MITCK SERVICE BULLETIN

SB269

Replacing Obsolete Transformers

Affected Machinery: $Finish\ Roller\ II^{^{\text{TM}}}$, $Finish\ Roller\ Roller\ Press$, $Peak-Up\ Truss\ Stacker\ and\ Truss\ Receiver\ Stand$, $RailRider\ Pro^{^{(\!R)}}$ Floor\ Truss\ Press\ System, $Roller\ Gantry\ with\ MiTek^{^{(\!R)}}$, $Tee-Lok^{^{(\!R)}}$, or $Robbins\ Tables$, $RoofGlider^{^{(\!R)}}$ Roof\ Truss\ Roller\ Press, and Stand-Alone\ Conveyor\ and powering kit

Figure 3: Wiring Diagrams by Voltage

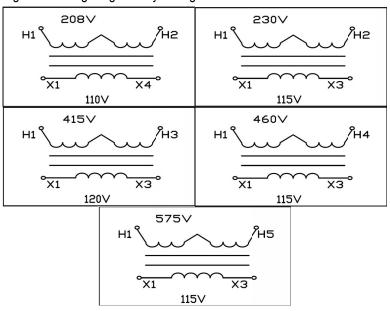
- 1. With power locked out as previously described, remove the existing transformer by dismounting it from the electrical panel.
- 2. Replace the existing transformer with new transformer and fuse blocks provided.
 - a) Mount the new transformer to the mounting holes used by the transformer being replaced. If this is not possible, create a new mount with appropriate spacing and orientation for the new transformer.
 - b) Run wiring through the new transformer's wiring ports (Figure 2). Reference Table 2 to determine which tabs to use depending on the voltage of the panel, and which tabs for the desired output voltage.

Table 2: Tabs Usage by Voltage.

Line Side (Input Voltage)		Load Side (Output Voltage)	
Voltage In	Connection	Connection	Voltage Out
575	H1-H5	X1-X3	115
230	H1-H2	X1-X3	115
208	H1-H2	X1-X3	110
460	H1-H4	X1-X4	125
416	H1-H3	X1-X4	130
